**Amendments to the Drawings**

Applicant: Robert B. Chaffee  
Serial No: 09/859,706  
Confirmation No: 4125  
Filed: May 17, 2001  
For: INFLATABLE DEVICE WITH RECESSED FLUID  
CONTROLLER AND MODIFIED ADJUSTMENT DEVICE

*Fig. 3*

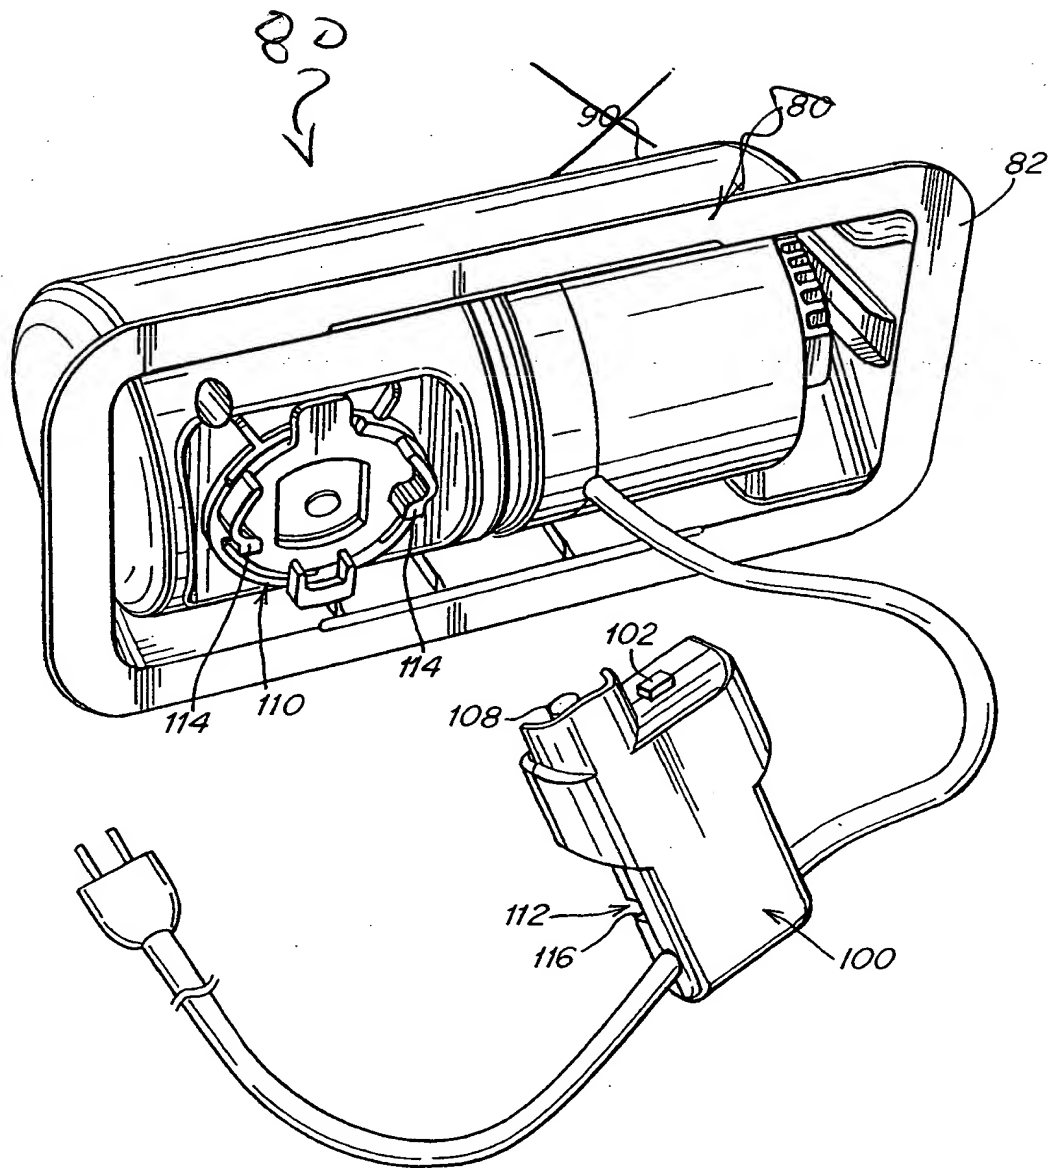
The Office Action objects to the drawings as failing to comply with 37 CFR 1.84 (p)(4) because reference character “90” has been used to indicate both the housing “90” connected to the flange “82” as shown in FIG. 3 and the housing or covering around the motor (84), impeller (86), conduit (88), solenoid (104), etc. as shown in FIG. 5. Applicant has deleted reference character 90 from FIGS. 3 and 4 of the enclosed annotated drawings so as to eliminate any confusion. It is clear from the specification that the reference character 90 refers to the housing 90 that surrounds the inner workings of the pump 81, such as the motor (84), impeller (86), conduit (88), solenoid (104), etc., and can also serve as a connection between the fluid controller 80 and the bladder 20. Accordingly, withdrawal of this objection is respectfully requested.

As to claims 5, 6, 8, 9, and 26, the Office Action asserts that they all recite a "housing" which is confusing because the specification and drawings are not clear as to what constitutes the housing (i.e., is it the structure connected to the flange (82) as shown in FIG. 3 or is it the structure surrounding the motor (84), impeller (86), conduit (88), solenoid (104), etc. as shown in FIG. 5?). As has been discussed above, the housing 90 surrounds, for example, the motor, the impeller, the conduit, the solenoid, etc. as shown in FIG. 5 and any reference to the housing 90 in FIGS. 3 and 4 have been deleted. Thus, the drawings have been corrected and the claims are

The Office Action also objected to the drawings asserting that the reference numerals “83” and “90” have both been used to designate “fluid impermeable wall” (see FIG. 5) and “housing” (see FIG. 3). As noted above, FIGS. 3 and 4 have been amended to eliminate to reference character “90” from these figures, as the fluid impermeable wall is designated by the reference number 83 in FIG. 5. Accordingly, the drawings have been corrected and withdrawal of this objection is respectfully requested.
